COMMITTEE OF THE WHOLE SEPTEMBER 18, 2006

SITE DEVELOPMENT FILE DA.97.044
THE ROYALTON (2001) INC.

Site Plan

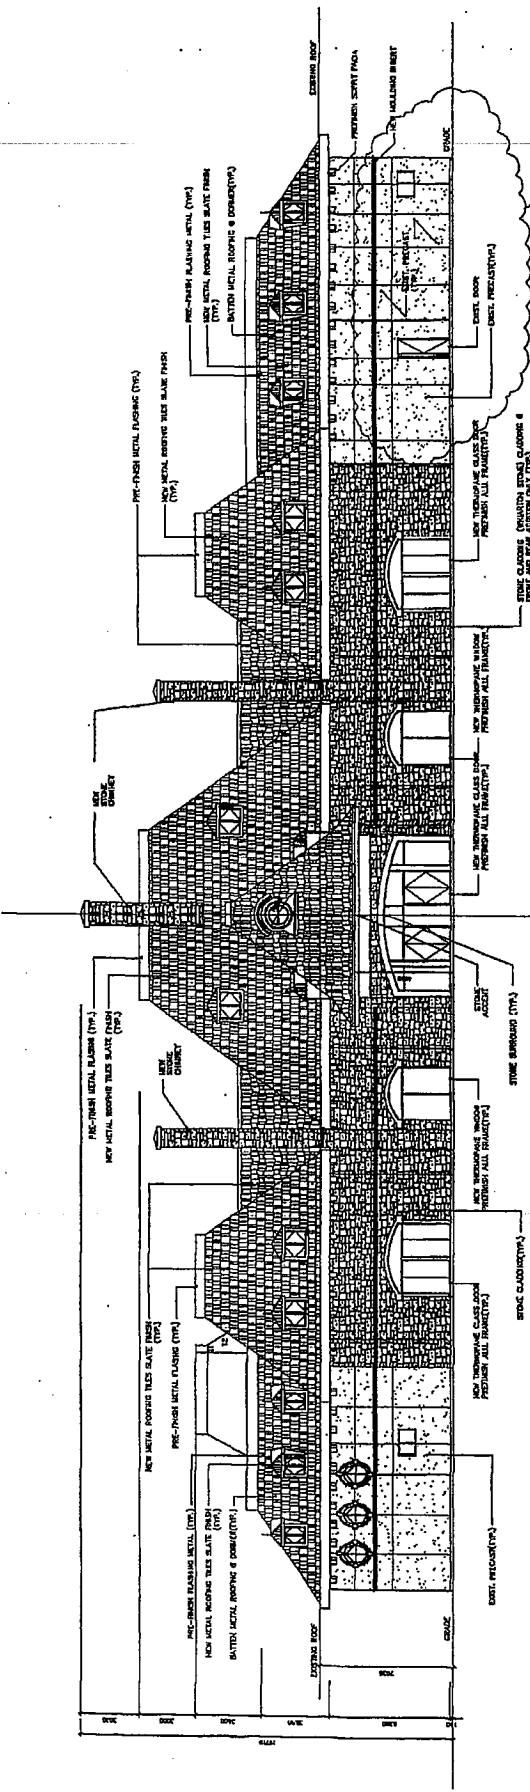
The Region of York is protecting for a 45m right-of-way along Jane Street, and will require lands for a setback of 22.5m from the centreline of construction. The Owner will need to revise their plans accordingly to meet this requirement, if necessary, upon the applicant submitting the necessary plans for confirmation by the Region of York. The Owner will need to proceed to the Committee of Adjustment, if any additional variances are required as a result.

North & South Elevations

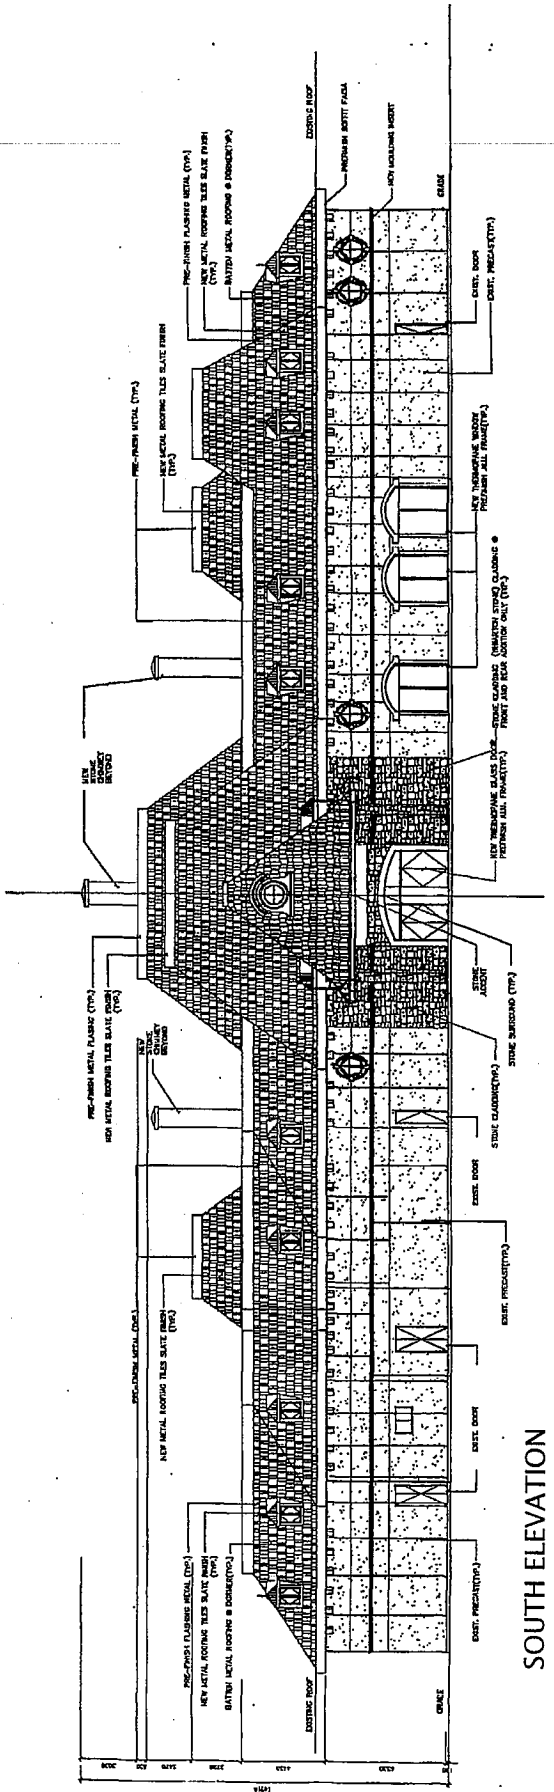
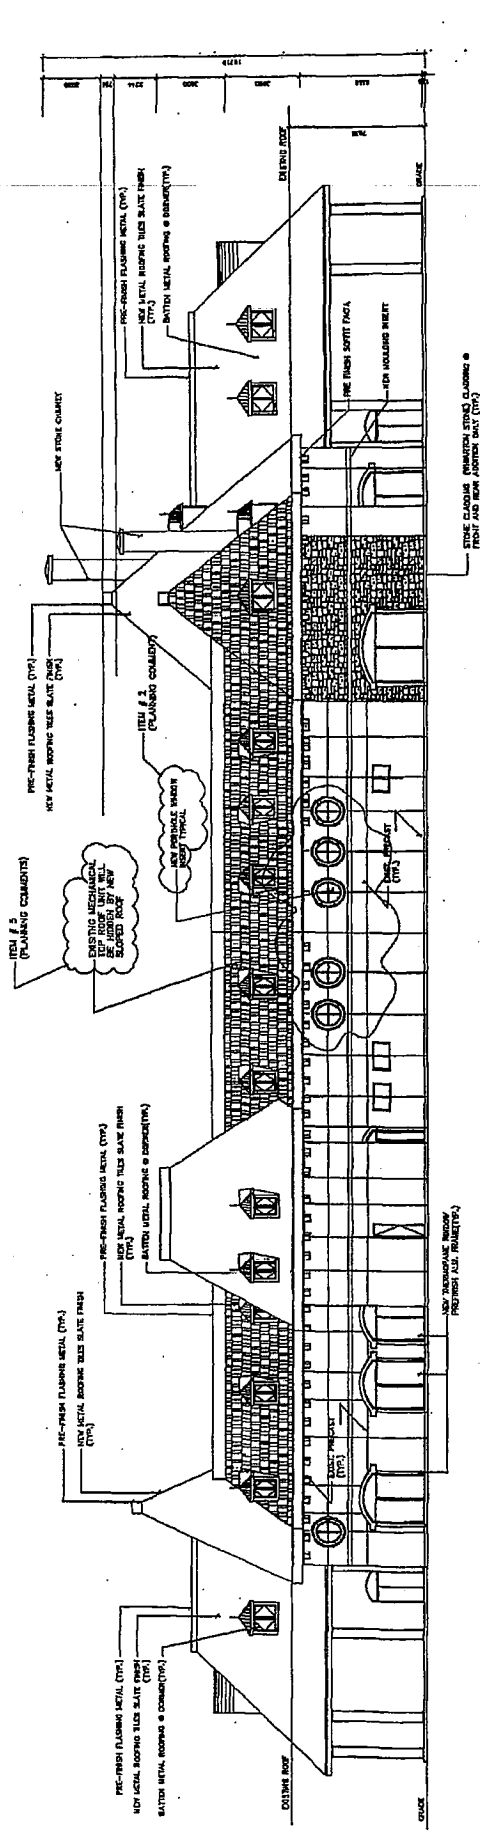
The Development Planning Department is generally satisfied with the proposed elevations, however, is requesting that the Owner continue to work with Staff and consider the addition of stone cladding along the base of the existing precast concrete panels to tie together the old material with the new material.

- a) That prior to the execution of the site plan agreement:
 - i. the final site plan and building elevations including the provision of additional stone cladding along the base of the existing precast wall shall be approved to the satisfaction of the Development Planning Department;
